Docket No. 52-021
MHI Ref: UAP-HF-10148

Subject: Transmittal of Markups of US-APWR DCD Chapter 15.6.5 Small Break LOCA

Markups of US-APWR DCD Chapter 15.6.5 Small Break LOCA

15.6.5 Loss-of-Coolant Accidents Resulting from Spectrum of Postulated Piping Breaks within the Reactor Coolant Pressure Boundary

Figure 15.6.5-21 PCT at All Elevations for Hot Rod in Hot Assembly for 7.5-inch Small Break LOCA

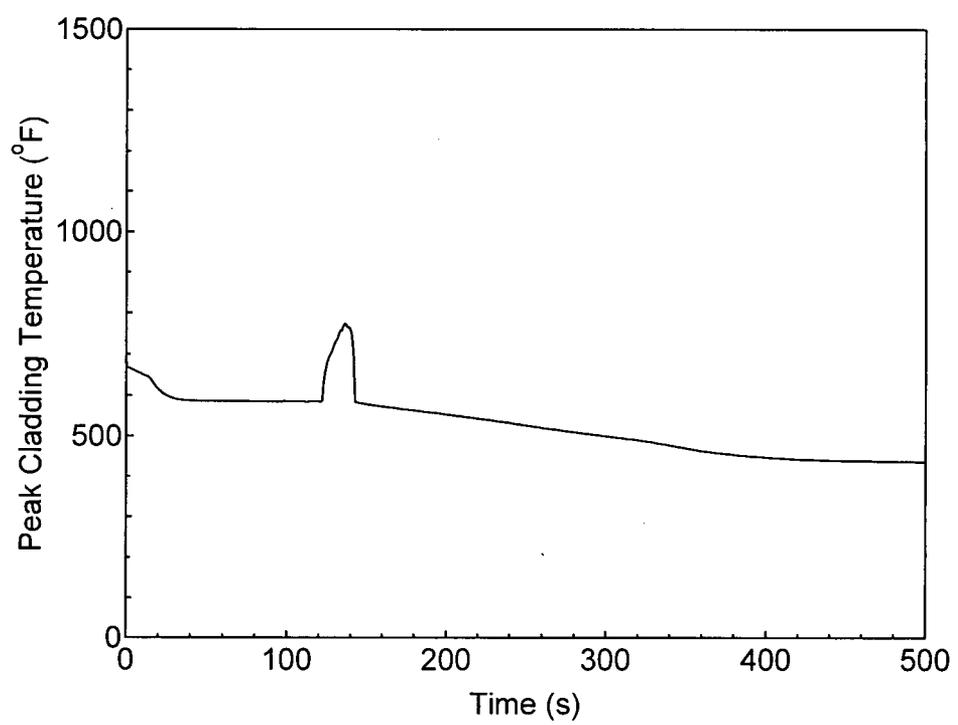
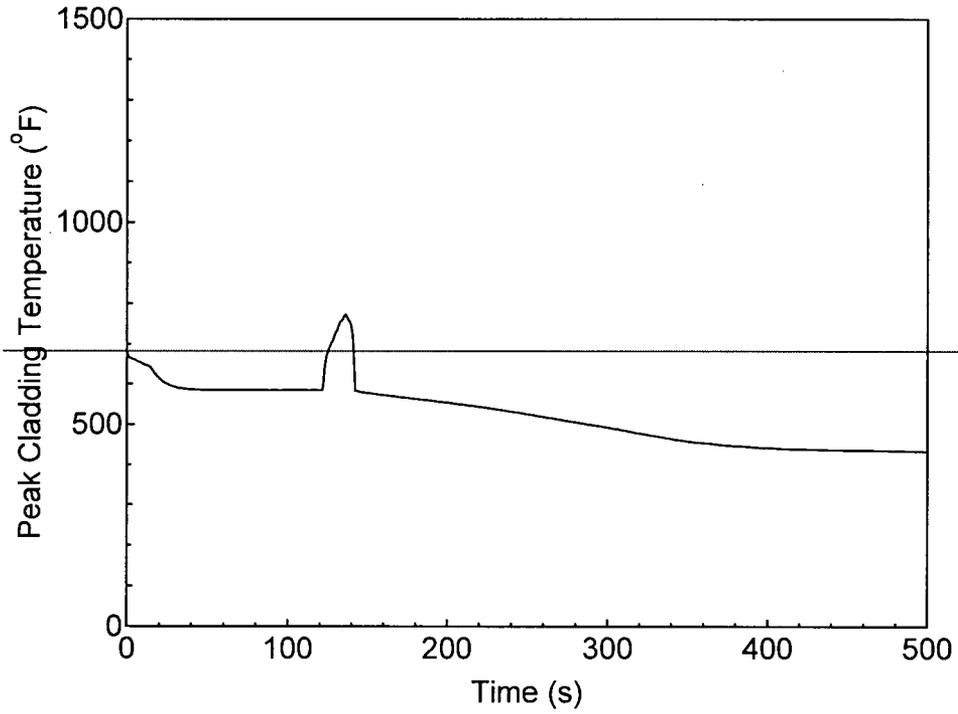
Figure 15.6.5-21 shows the PCT at all elevations for the hot rod at the maximum allowed linear heat rate and the average rod in the hot assembly that contains the hot rod. The PCT of ~~773~~775°F occurs at 136 seconds. This figure demonstrates that the PCT is substantially lower than 2200°F.

Figure 15.6.5-26 Accumulator and Safety Injection Mass Flowrates for 1-ft² Small Break LOCA

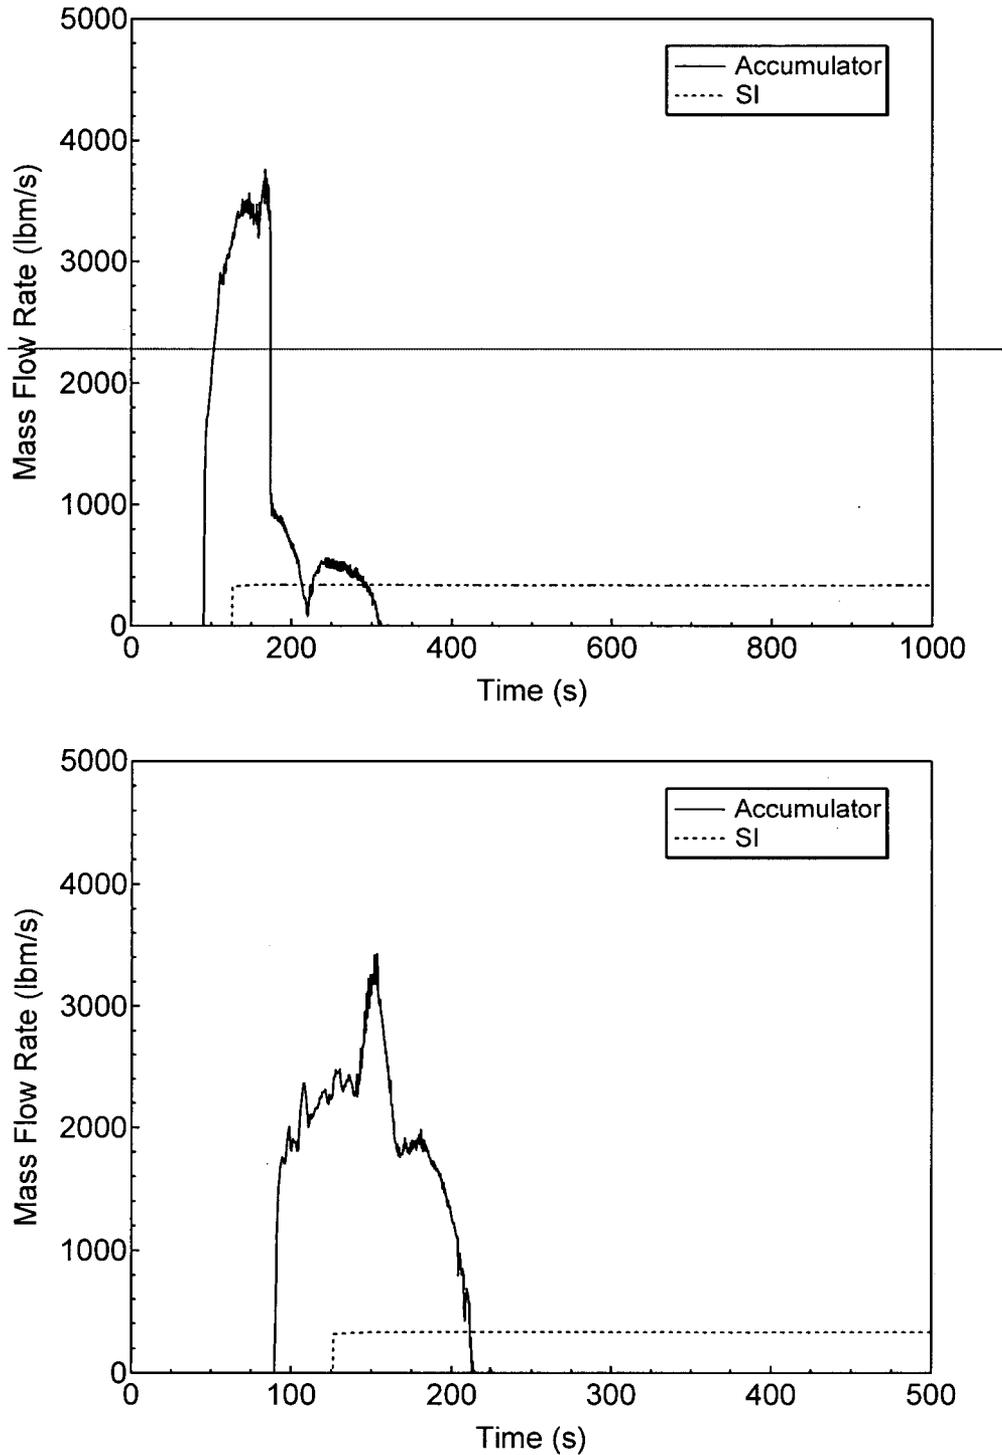
Figure 15.6.5-26 shows the accumulator and safety injection mass flow rates. The accumulators begin injecting borated water into the cold-leg at 80-89 seconds. The HHIS begins to inject borated water to the reactor core at 126 seconds. As a result of ECCS injection, the mass inventory is recovered. Figure 15.6.5-27 shows the RCS inventory transient. The downcomer liquid collapsed level and core/upper plenum liquid collapsed level transients are shown in Figures 15.6.5-28 and 15.6.5-29, respectively. Figure 15.6.5-30 shows the PCT at all elevations for the hot rod at the maximum allowed linear heat rate and for the average rod in the hot assembly that contains the hot rod. This figure shows that the PCT of 1323-1088°F occurs at 160-151 seconds. The PCT is significantly lower than 2200°F.
